Response to Comments

Draft Remedial Investigation and Feasibility Study

Jeld Wen Cleanup Site Everett, WA

Washington State Department of Ecology
Northwest Regional Office
Lacey, Washington
December, 2021

Figure 2: The location of sediment cores collected from the inlet and mouth of the inlet. The locations of all sediment cores are depicted in Figure 4.3-8 of the Draft Final RI/FS.

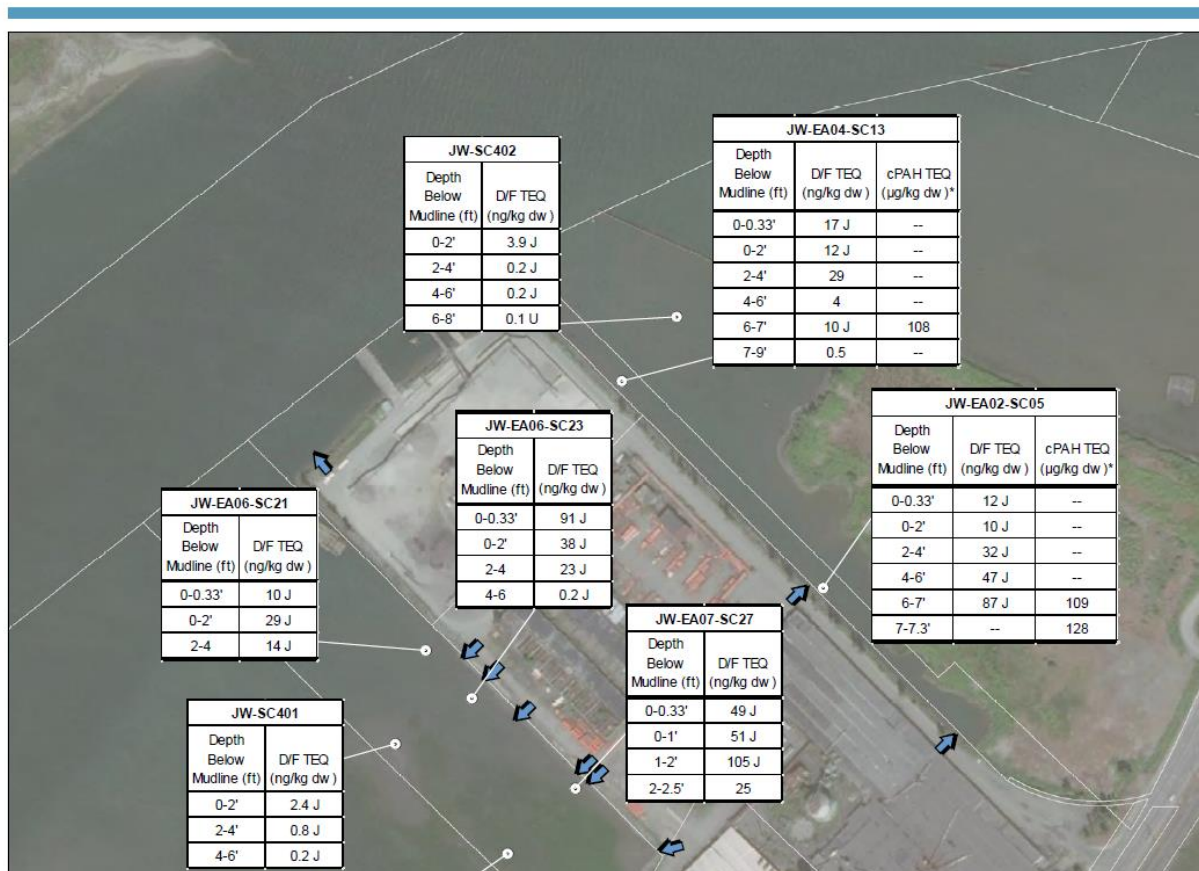
1. It is not clear how the sediment removal depth in the inlet was determined in any of the alternatives because no subsurface data were collected. The executive summary states "Elevated sediment concentrations adjacent to outfalls are present within mudflats both north (inlet area) and south of the upland property. Elevated dioxin/furan concentrations were detected at greater depths (up to 7 feet below mudline) than the total PCBs." Based on Figure 4.3-7, it does not appear that the subsurface in the inlet has been sampled next to the outfall and seeps adjacent to the contaminated creosote and Woodlife upland areas. Therefore, dioxin/furan data should be collected at depth near the surface sampling location with the highest dioxin/furan toxic equivalent (TEQ) at the Site (i.e., 144.4 ng/kg at 3SED8-b), and the basis for selecting 2 ft as the removal depth in Alternatives M4 and M5 should be discussed since it does not appear to account for the increase in dioxin/furan contamination with depth (at JW-EA02-SC05) (Figure 4.3-8). Note also that Figure 8.5-5 indicates some 4-ft removal in in the inlet area, which is inconsistent with the text and Exhibit 8.5. Please clarify Alternative M5 and the depth of removal.

Sediment removal depths in the inlet are based on data from three sediment cores collected in the inlet and mouth of the inlet (JW-EA04-SC13, JW-EA02-SC05, and JW-SC402) as well as by using surface sediment samples. See Figure 2 below for the locations of subsurface core sampling. Exceedances of dioxins/furans and cPAHs were identified down to seven feet in two of the cores. Because subsurface data in the inlet is limited, Alternative M5 assumed an engineered cap would be necessary for some areas with higher levels of surface sediment exceedances; those areas are assumed to have subsurface contamination. The orange line in Figure 8.5-5 represents bulkhead removal, rather than a 4-foot removal depth. The removal depth in the inlet for Alternative M5 is nominally 2 feet, with an engineered cap.

Additional surface and subsurface data from the inlet will be collected during remedial design phase to further characterize exceedances and physical characteristics. This information will be used to refine the remedial footprint in the inlet. Based on available sediment data, a two to three foot thick engineered cap is anticipated to provide adequate protection to human and ecological health in the inlet. The horizontal or vertical extent of the cap may be adjusted based on additional information. Conversely, if subsurface contamination is not present in some areas currently designated for engineered capping, these areas may instead be excavated and backfilled with clean material (no engineered cap).

Figure 1. Comparison of dioxin/furan patterns in inlet sediment and Woodlife soil

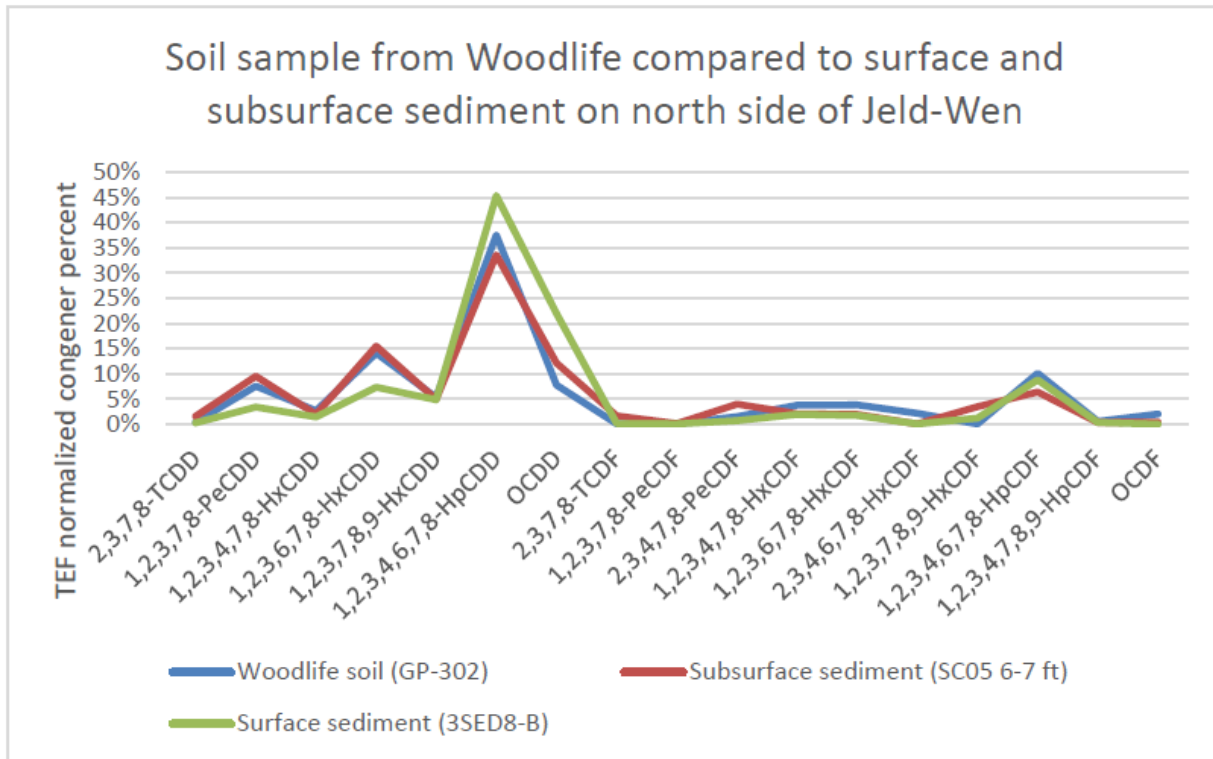
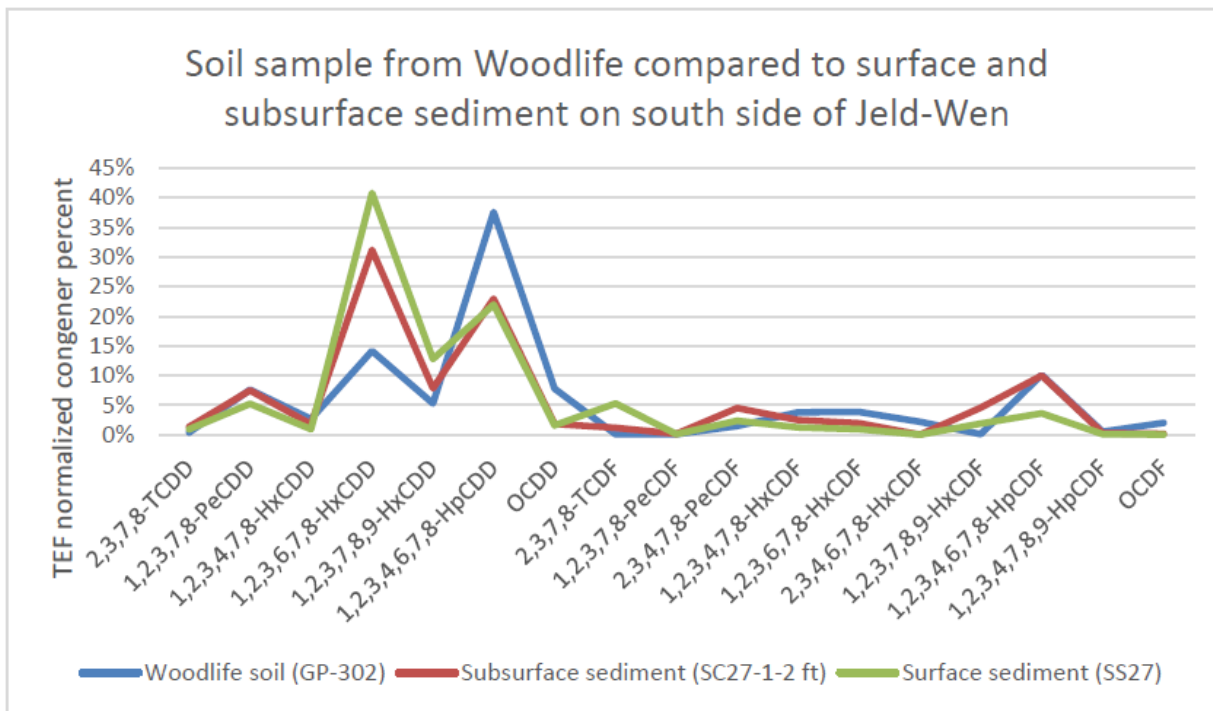
The congener patterns of dioxins/furans in soils and sediments within the inlet suggests that the patterns in sediment are consistent with the pattern in soil in the Woodlife area. The patterns in both the soil and sediment samples from the Woodlife area are dominated by the contribution of 1,2,3,4,6,7,8-heptachlorodibenzo-p-dioxin (HpCDD) (Figure 1). It is also important to note that the patterns in both surface and subsurface sediment in the inlet are similar (i.e., HpCDD dominated), suggesting a continuing source. The eroding bank should be characterized during design.

Samples with elevated dioxin/furan TEQs from sediment near outfalls south of the Site had a different pattern (Figure 2). Both the surface and subsurface sediment patterns had greater contributions from 1,2,3,6,7,8-hexachlorodibenzo-p-dioxin. It would be helpful to compare this pattern with that of upland sample SS-301, which is a boiler ash sample. However, the congener data for this sample are not provided in Table 5.3-1. These results should be added.

Figure 3: Indicator hazardous substance PCL exceedances – cPAHs (TEQ) in soil

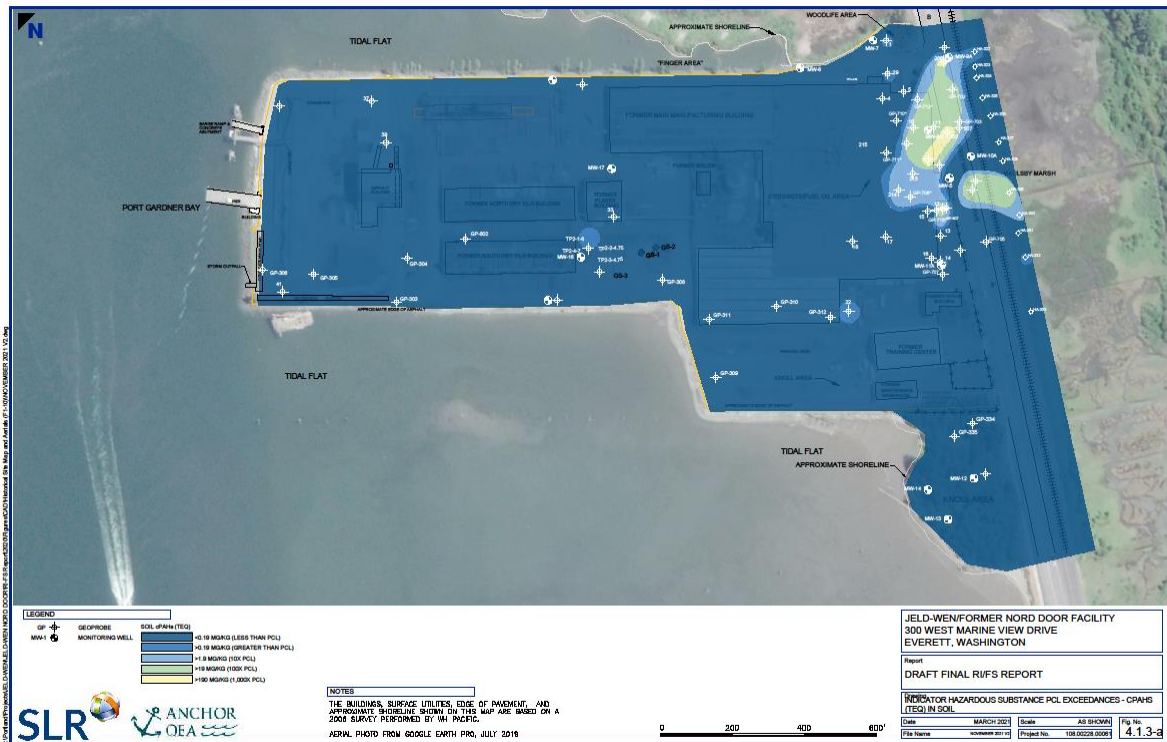
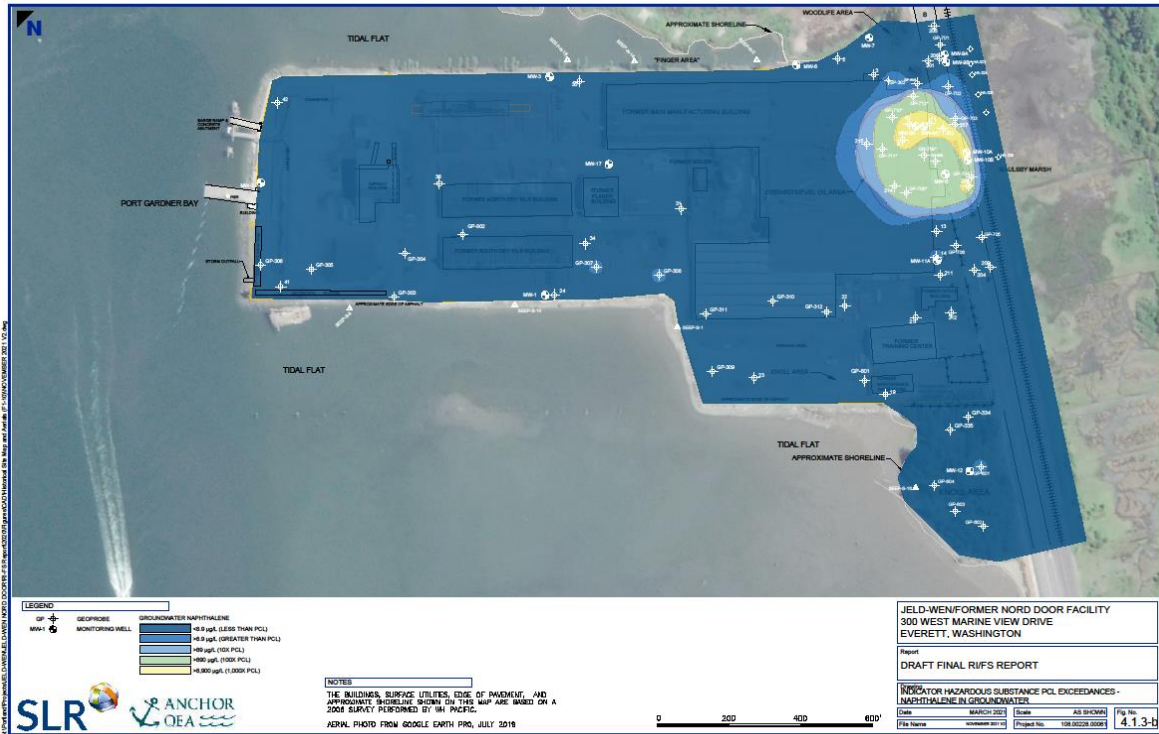
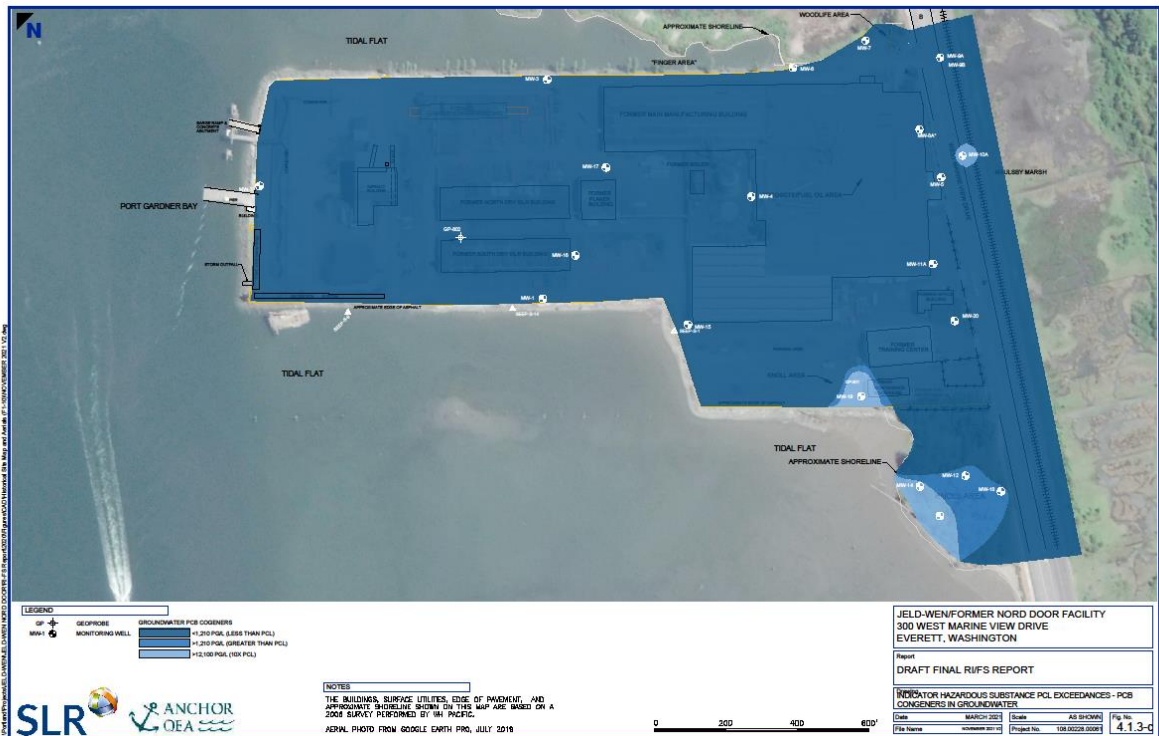
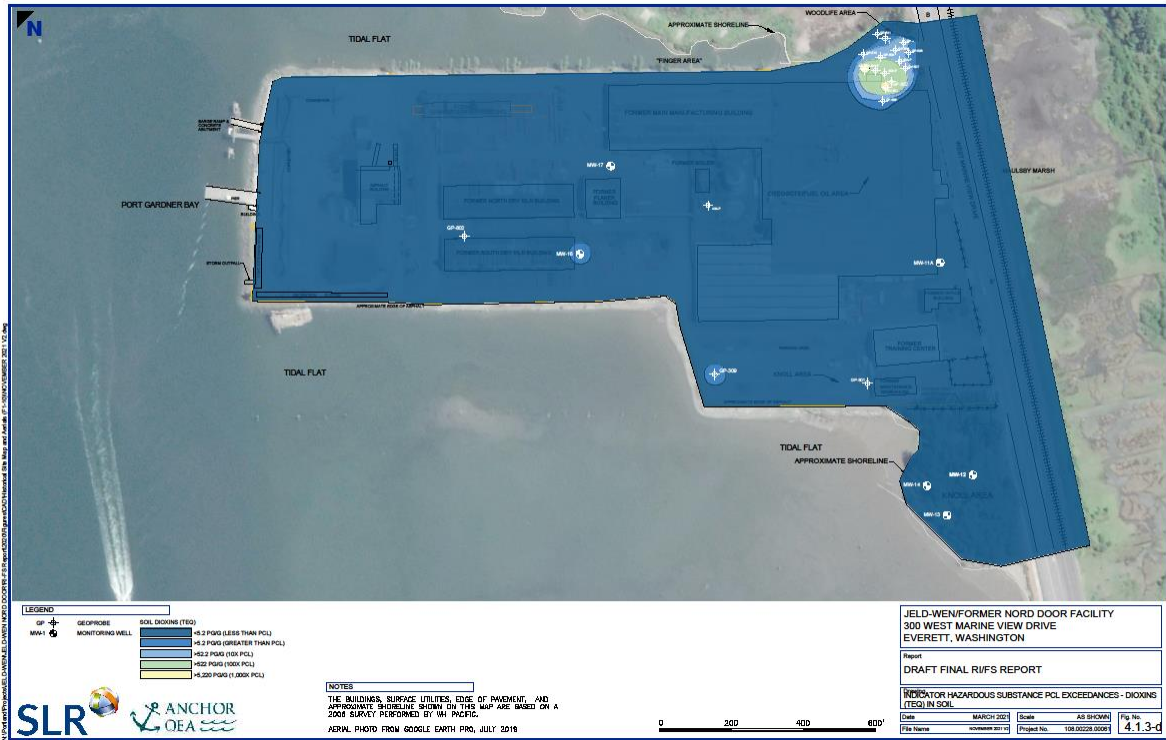
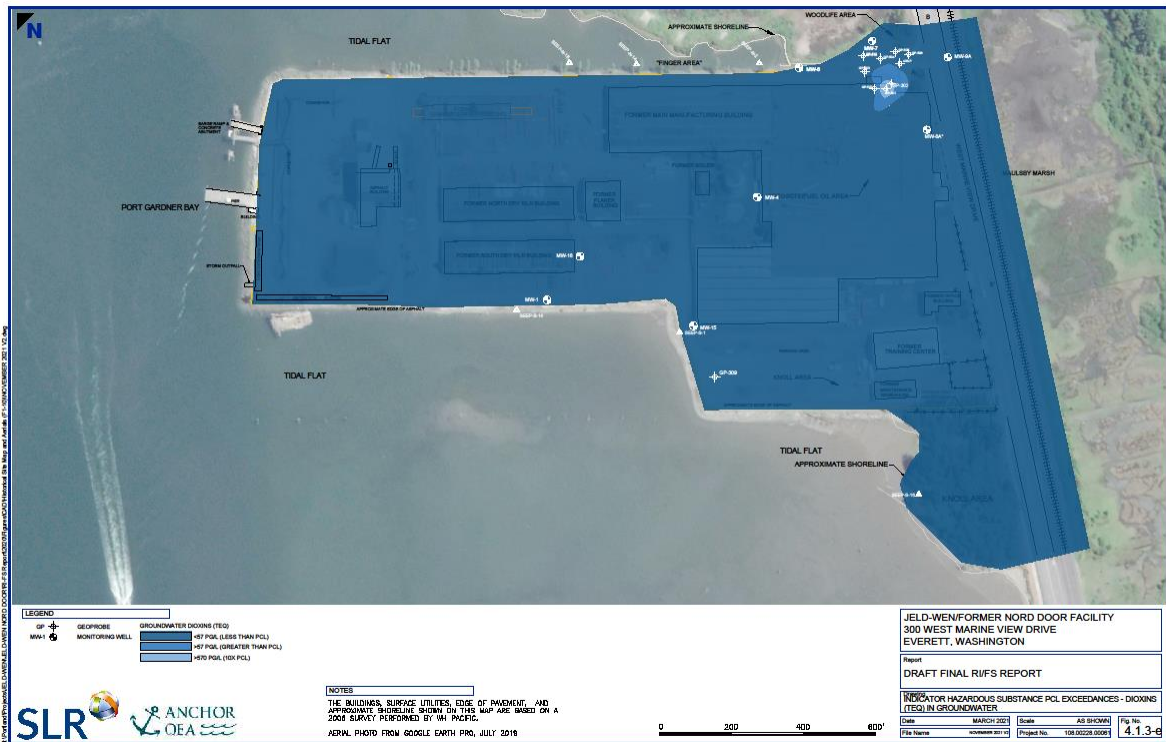
11. The RI does not present information clearly enough to readily understand environmental conditions for the entire upland area. Although the upland area of the Site is composed of more than 35 acres, the RI narrative discusses conditions for the Creosote/Fuel Oil Area, Woodlife Area, and Knoll Fill Area only, which collectively comprise a relatively small percentage of the entire upland area. The RI/FS should present the data to show that the remaining majority of the upland area meets cleanup standards.

Ecology agrees that not all the upland data were presented within the document graphics, specifically for all individual PCB congeners, dioxin/furan congeners, PAHs, VOCs and SVOCs. Table 4.1-1 to Table 4.1-26 provide summary results and individual sample results for chemicals that were detected at higher frequency. Table 4.1-1 and 4.1-2 were updated to include chemicals that were analyzed for but not measured above the laboratory detection limit in any samples. The following additional text was added in Section 4.1.2.1 to discuss the selection of Indicator Hazardous Substances (IHS) for the upland property.

Graphics (Figure 4.1.3 – a through e) were added to Chapter 4 upland area investigation (similar to the sediment data graphics presentation) to better represent the contaminated soil and groundwater areas throughout the site. These graphics show where the IHS were sampled throughout the site and where these IHS exceed Preliminary Cleanup Levels (PCL). Those additional graphics are also included below as Figures 3 to 7.

The following text was added to Section 4.1.2.1 to characterize other isolated areas of impact.

Dioxins were identified in sample SS-301 above the PCL. This sample was collected from residual boiler ash material stored in a drum and its location as shown on Site figures in this report is relative to the location of the drum at the time of sampling. An additional boring, 404-P, was completed immediately adjacent to the drum and did not identify dioxins above the PCL.”

Figure 8: Creosote/fuel oil area alternative 7 - hotspot removal and bioremediation.

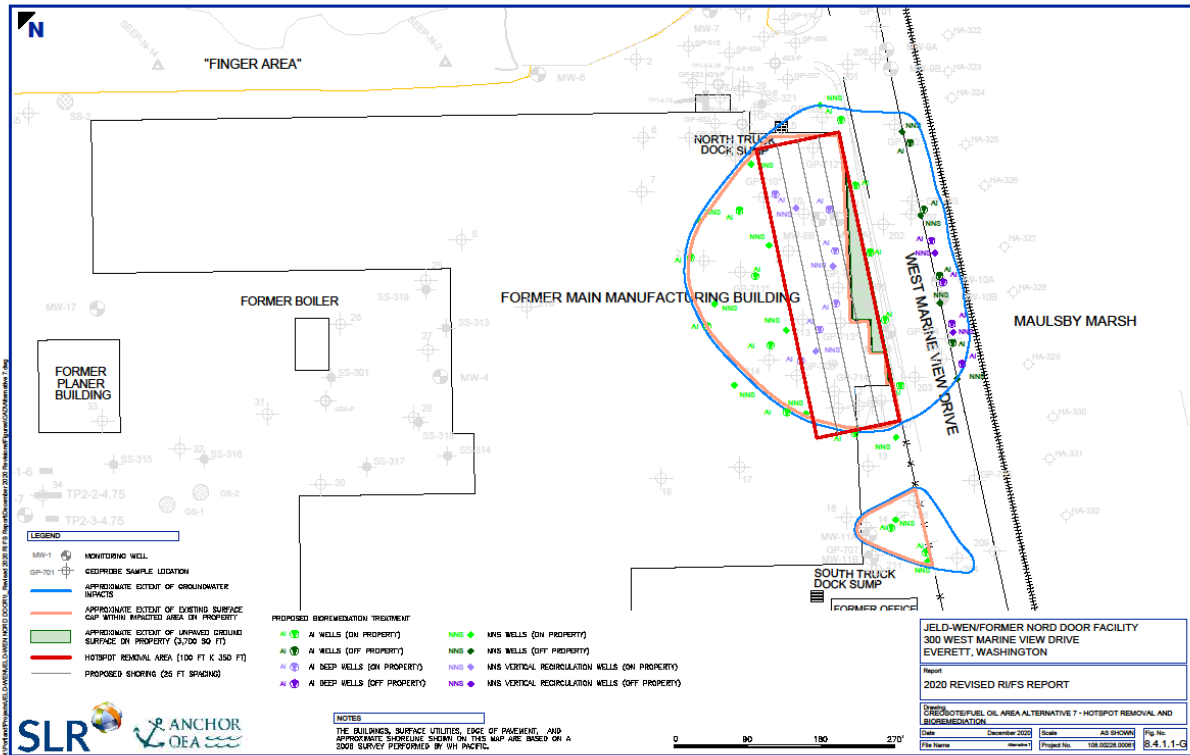
2. Firstly, I'm not finding a plan drawing for Creosote/Fuel Oil Area alternative #7. Could this document be availed to us?

Thank you for your comment. The figure for Alternative 7 (Section 8.4.1.1) was missing from the draft final report. The missing figure is included below (Figure 8) and is included in the Final RI/FS report as Figure 8.4.1.1-G.

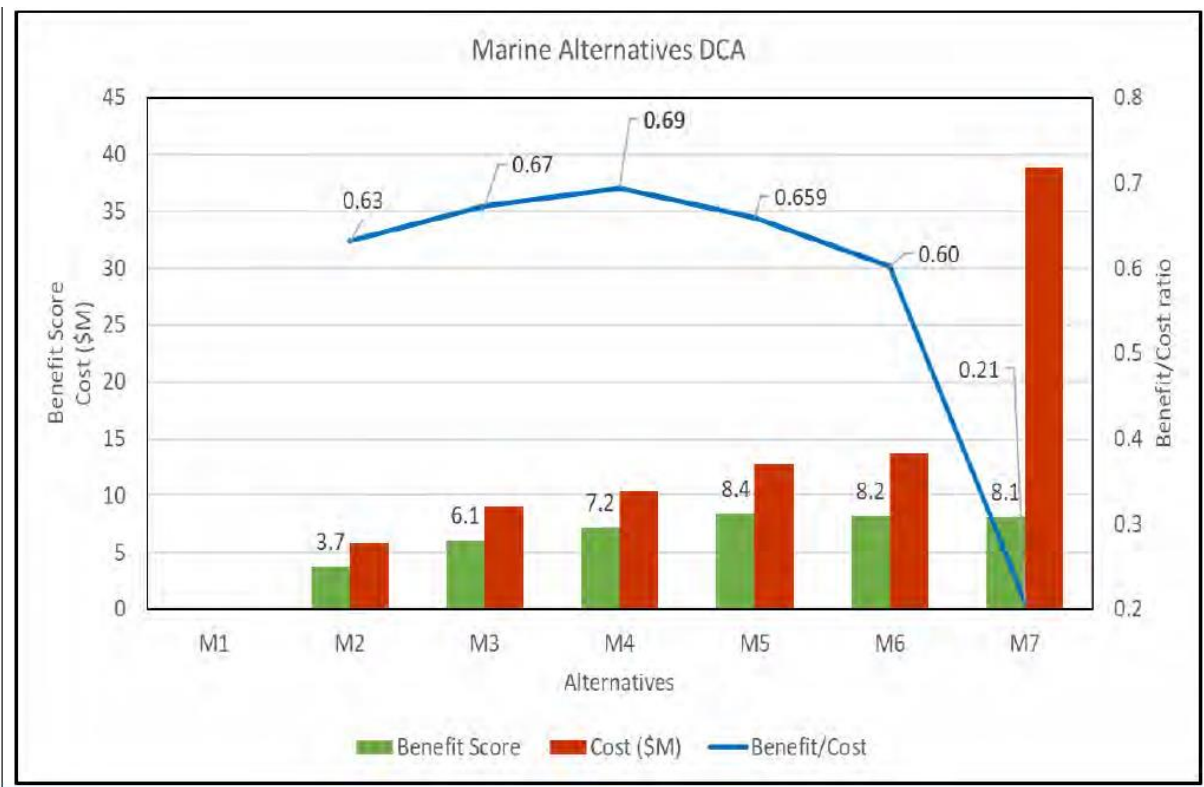
6. If contaminants will remain in the Knoll Fill Area, what will be done to prevent these contaminants from potentially entering the marine environment over time?

Chemicals of concern in the Knoll Fill Area include low level PCBs in groundwater. No sources of PCBs were found in the fill material itself. It is possible the Knoll Fill Area prior to filling had low level PCB contamination similar to some areas in the mudflat. Passive sampling with solid-phase microextraction (SPME) indicated that the concentration of PCBs in groundwater is less than that of in the sediment pore water in the mudflat. As such, PCB contamination can move from the sediment to groundwater due to tidal action and diffusion. Remediation of PCBs from sediment will likely reduce that movement and eventually reduce groundwater PCBs. Long term monitoring will establish the trend. If long term monitoring shows potential recontamination of the sediment or the marine environment, this will trigger additional investigation and further action.
